# NEW YORK STATE DEPARTMENT OF ENVIRONMENTAL CONSERVATION

**Re: Supplemental Design Plan – SVI Corrective Measures; November 6, 2018  
General Circuits, Inc. Site #828085  
City of Rochester, Monroe County**

The New York State Departments of Environmental Conservation (NYSDEC) and Health (the Departments) have completed their review of the document entitled *“Supplemental Design Plan – SVI Corrective Measures”* (the Work Plan), dated November 6, 2018 and prepared by Day Engineering, P.C. for the General Circuits, Inc. site in the City of Rochester, Monroe County. In accordance with 6 NYCRR Part 375-1.6, the Departments have determined that the Work Plan, with modifications and clarifications, substantially addresses the requirements of the Order on Consent. The modifications are outlined as follows:

FIGURE 6 (revised 5/22/18)

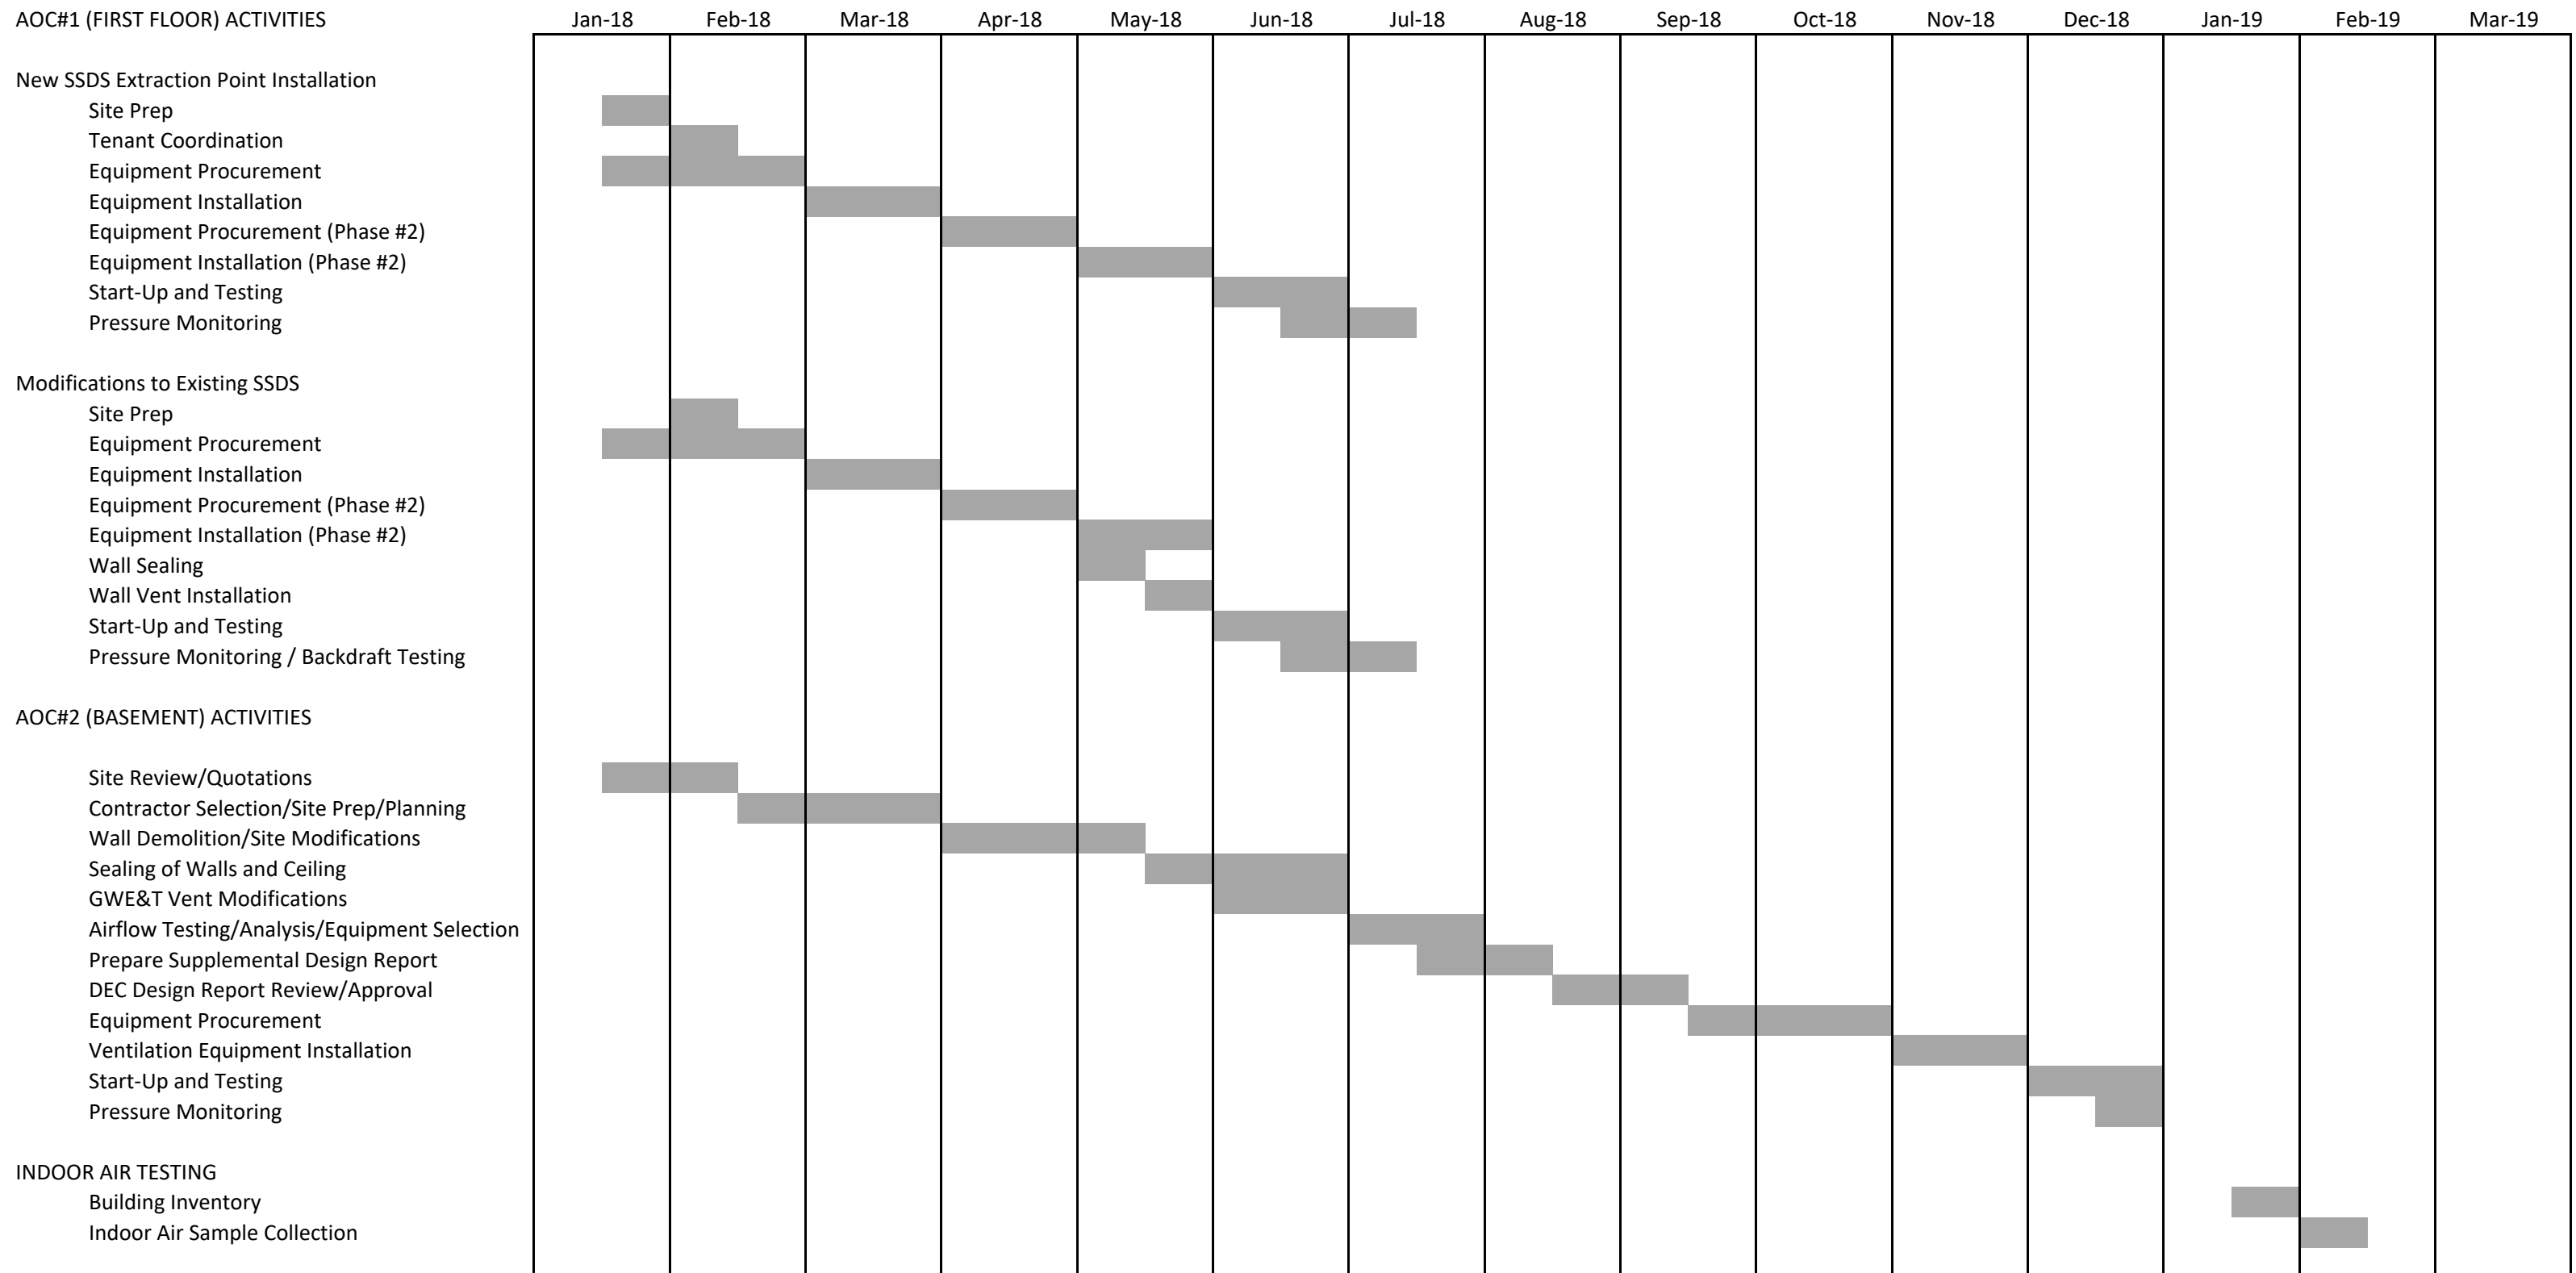
The revised schedule dated May 22, 2018 (attached) is approved with the following conditions/clarifications:

- The AOC #2 Supplemental Design Report (AOC #2 work plan) will be submitted to NYSDEC and NYSDOH by August 21, 2018;
- NYSDEC does not commit to approving the AOC #2 work plan within 30 days of submittal.
- Once the AOC #2 Supplemental Design Report is approved:
  - Equipment Procurement will be completed within 6 weeks of AOC #2 work plan approval;
  - Ventilation Equipment Installation will be completed within 10 weeks of AOC #2 work plan approval; and
  - Start-up testing and pressure monitoring will be completed within 14 weeks of AOC #2 work plan approval.

- The Indoor Air Sample Collection Task also includes soil vapor intrusion samples in AOC #1, as needed.
- A building inventory and preliminary indoor air and soil vapor intrusion sampling for AOC #1 will be completed by February 15, 2019 regardless of the status of AOC #2 mitigation system. If construction of the AOC #2 mitigation system is delayed beyond the dates in the attached schedule, then additional indoor air and soil vapor intrusion sampling will be completed, as needed, in accordance with the schedule in the approved Corrective Measures Design Plan.

FIGURE 1

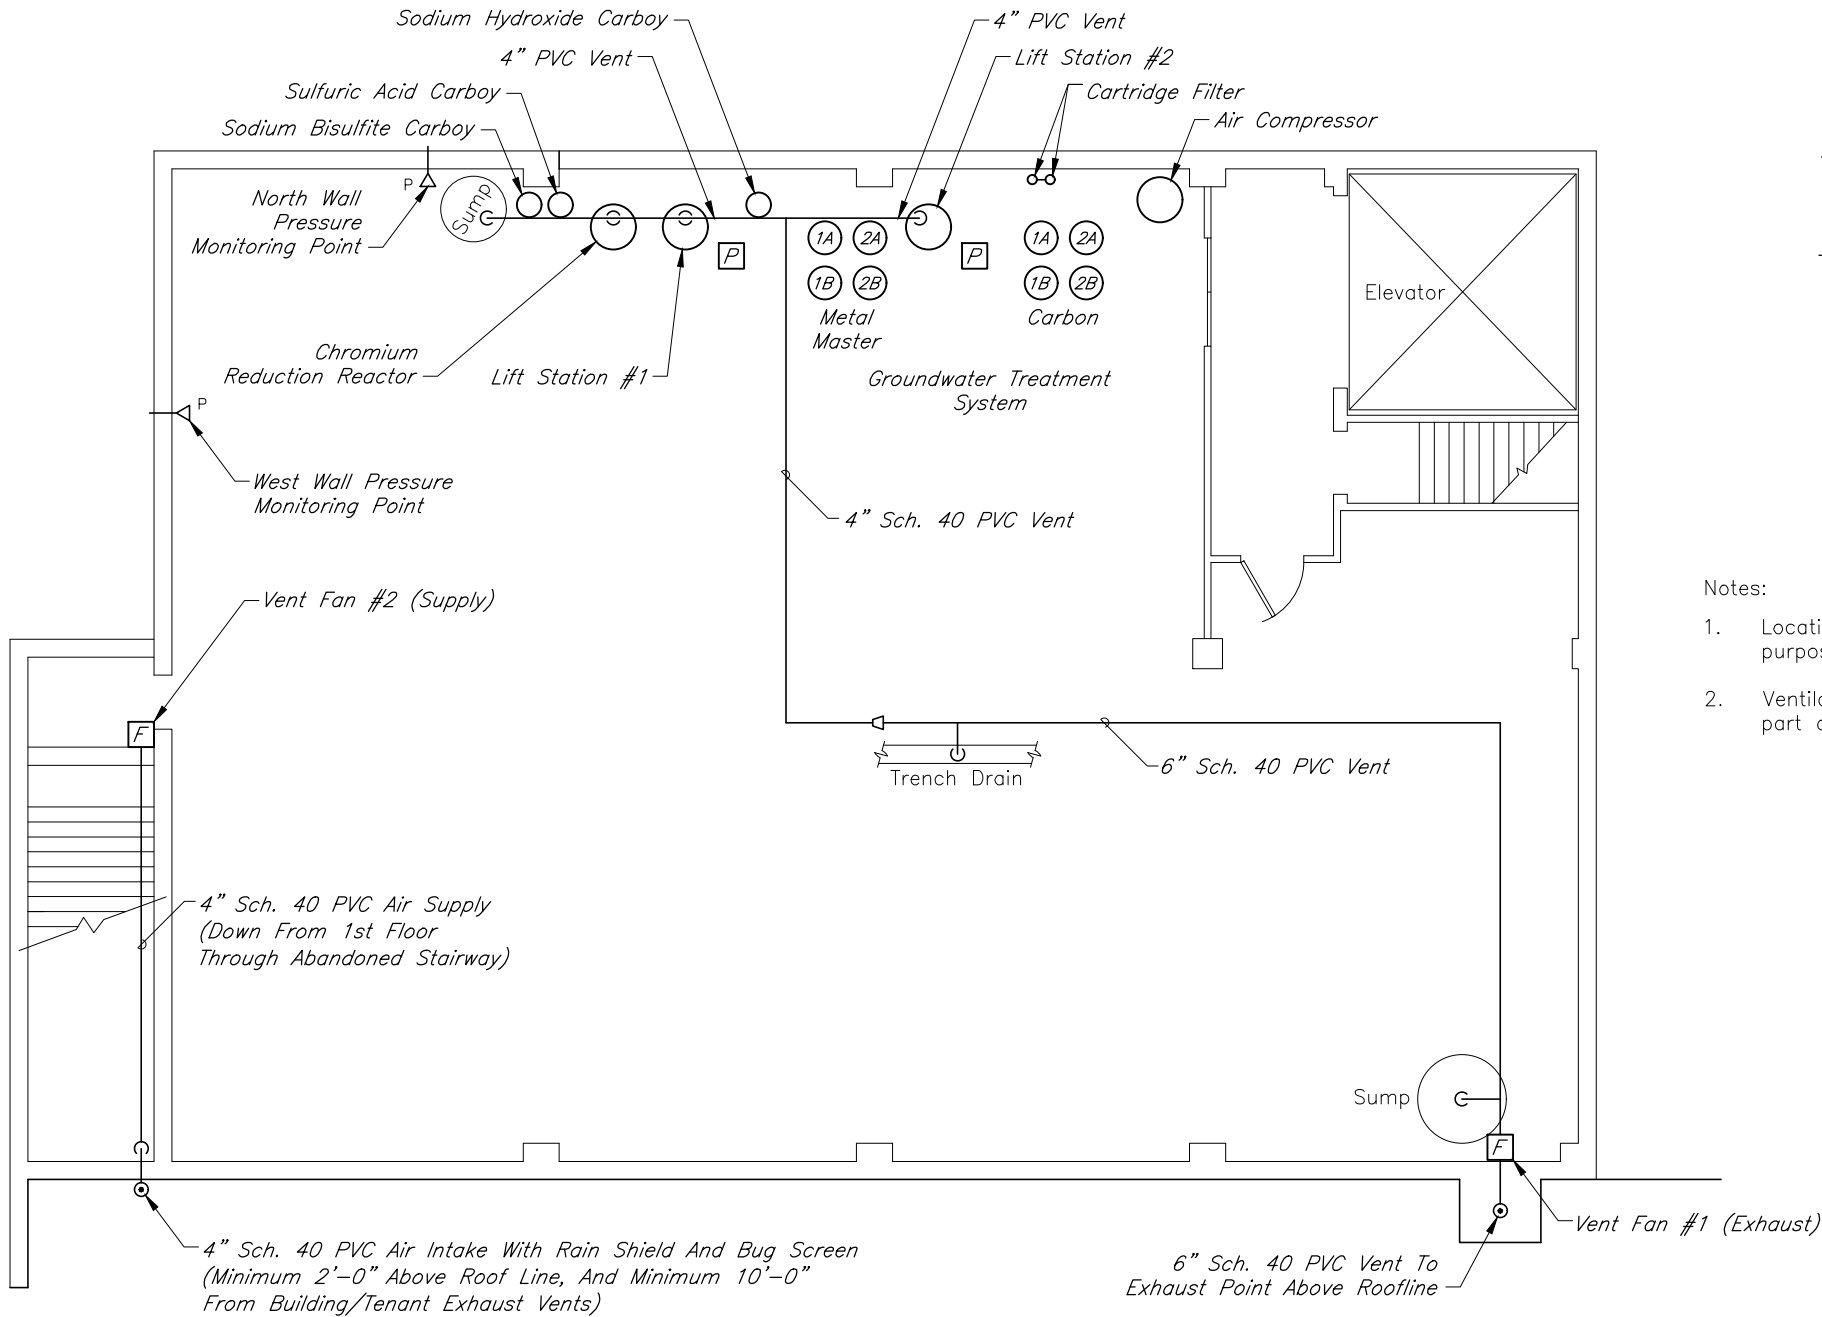
1. Post-construction outdoor air samples will be collected from two locations; one location in the parking lot, just south of the fresh air intake, and a second location on the roof nearest the fresh air intake.
2. The positive pressure system will be labeled to identify it as part of a soil vapor intrusion mitigation system.
3. The Work Plan will be completed in accordance with the revised schedule dated May 22, 2018 and all associated revisions and conditions included in NYSDEC's June 5, 2018 email approval (enclosed).
